Memorandum

18 August 2021

Subject: Preliminary review of reporting submitted in advance of an application for a Proposed Plan Change at 41-43 Brigham Creek Road, Whenuapai

Figure 5: From Auckland Council Geomaps. Extent of Overland Flow Paths, Floodplain & flood prone areas and Historic Horticulture Overlay (green cross hatching) over 41-43Brigham Creek Road

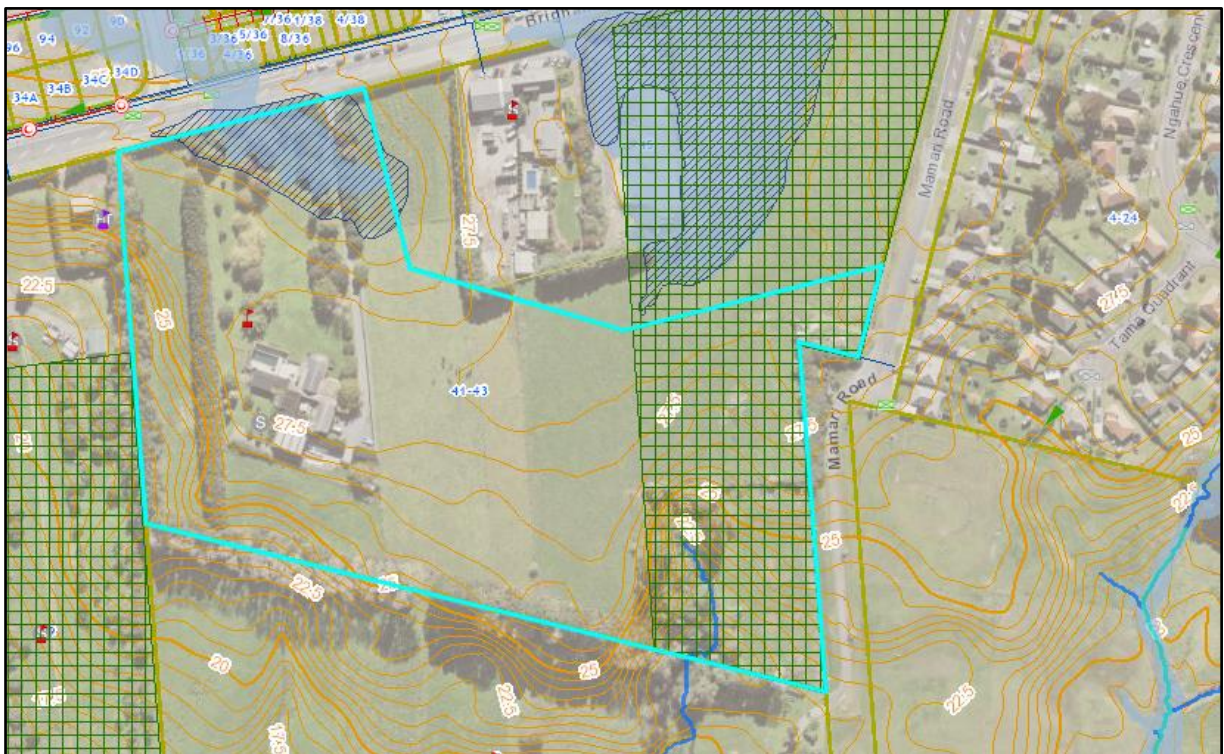
29. Figure 5 above, shows part of the subject site has a historic horticulture overlay. Marija Jukic, Senior Specialist within the Contamination, Air & Noise Specialist unit reviewed the proposal documents and concluded that a Preliminary Site Investigation of Contaminated Land (PSI) report will be required to be prepared and submitted with any future application for a plan change of the subject site.
30. Please refer to Appendix 1: Contaminated Land feedback PPC 41-43 Brigham Creek Road.

31. Part of the subject site features overland flow paths, floodplain & flood prone areas. The applicant has provided two reports which cover these topics:
 - a Wetland & Stream Ecology Report prepared by RMA Ecology Ltd dated 14 April 2021.
 - An Infrastructure Report prepared by Maven Auckland Ltd dated 12 April 2021,
32. Mark Lowe, Principal Environmental Scientist at Morphum Environmental Ltd acting on behalf of council reviewed the proposal documents where he concurred with the findings of the wetland assessment that there are no wetlands or streams on the subject property.
33. Please refer to Appendix 2 Ecological feedback PPC 41-43 Brigham Creek Road.

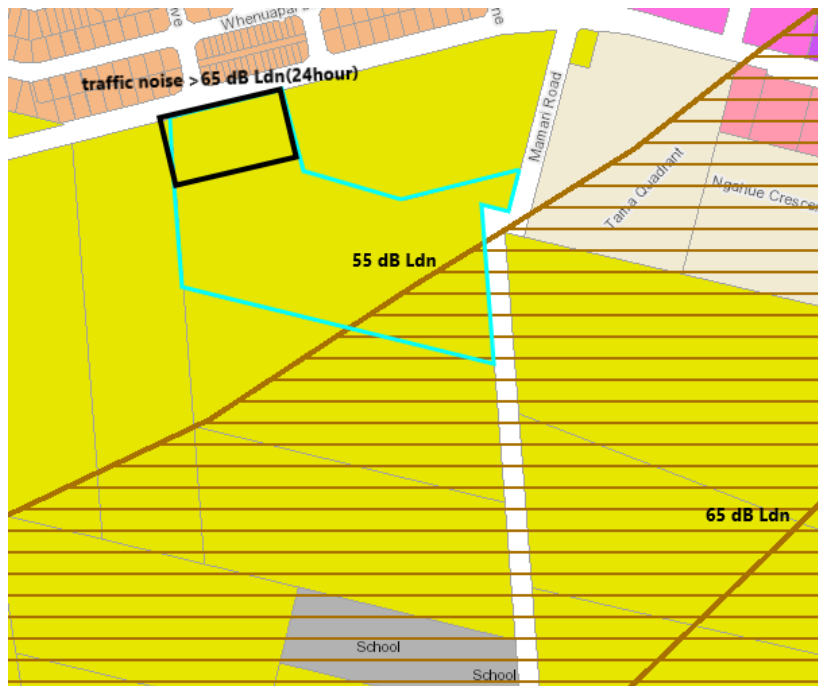
As Brigham Creek Road is a key east-west connection through Whenuapai and road widening would be required to upgrade Brigham Creek Road to an urban arterial road, I agree traffic noise is likely to be unacceptable inside new residential units nearest to the road. Accordingly, Marshall Day Acoustics (MDA) recommend that affected residential units will require acoustic treatment to enable an acceptable internal noise level to be met. MDA recommend a maximum internal noise level of 40 dB LAeq(24h). This is supported.

The submitted report does not include a prediction of future traffic noise levels. Accordingly, noise contours should be calculated based on recognised best practice to identify future traffic noise levels across the site and the likely number of affected residential units and hence extent of acoustic mitigation. This information is required to inform the acoustic design considerations for the site layout (e.g. setback distances, building line restrictions). The most affected area of the application site is indicated below.

Bus service Map (left), Whenuapai Travel Catchment (30 Mins) (middle), Census Data trip distribution for Whenuapai (right)

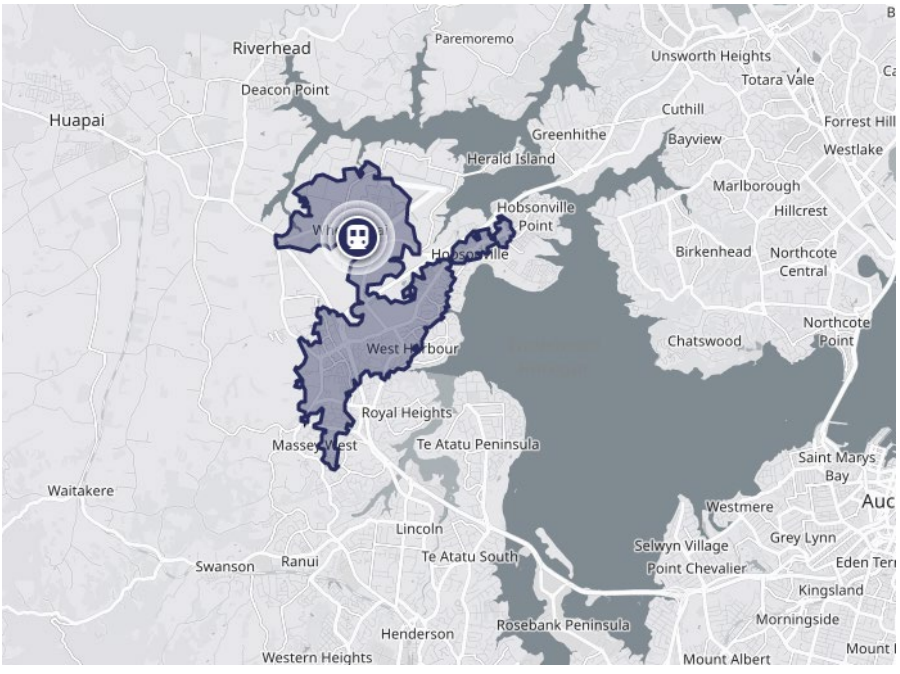
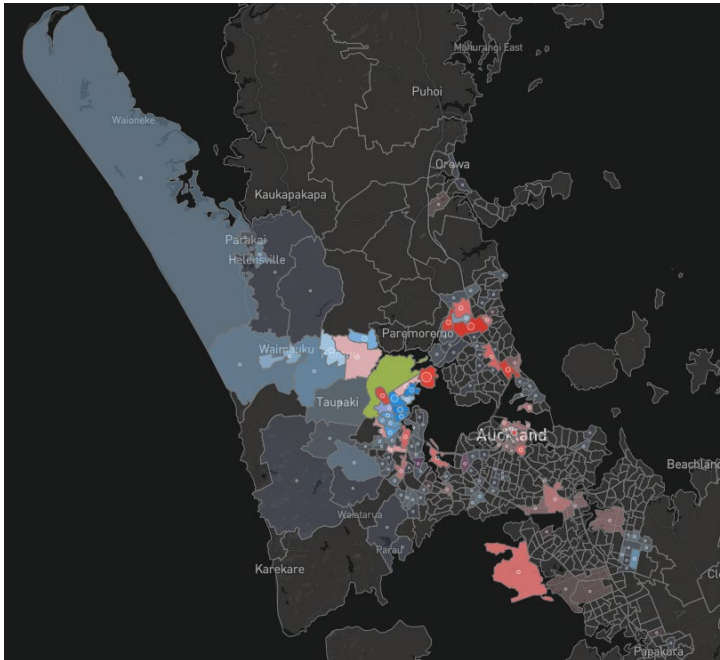
Existing public transport services as described in Section 2.5 of the ITA do not provide resilient connectivity to key destinations within Auckland. Whilst in future there are planned upgrades, this will impact on the ability of the proposed plan change to provide alternative options to the private vehicle for transport. The upgrades to public transport, as noted in the Whenuapai Structure Plan, do not have solid timeframes for delivery. At present, the 114 service is a local service that departs a minimum of once

per hour with lower frequencies in the early morning and evenings. The map below shows the catchment reach of public transport for a period of 30 minutes. As shown, a 30-minute journey catchment is unlikely to reach Hobsonville ferry terminal, but is likely to reach the Westgate bus services. Travel times at 8am from Brigham Creek Road to Auckland CBD during the AM peak periods is estimated to be from 1 hour 20 minutes to 1 hour and 45 minutes (Source Google Maps). Comparative travel times at 8am via private vehicle are typically 16-24 minutes (Source Google Maps). It is noted that Chloë's personal experience travelling during this peak period from West Harbour to the CBD are typically 45 minutes. This therefore demonstrates that until further services are developed the reliance on the private vehicle is likely to be significant.
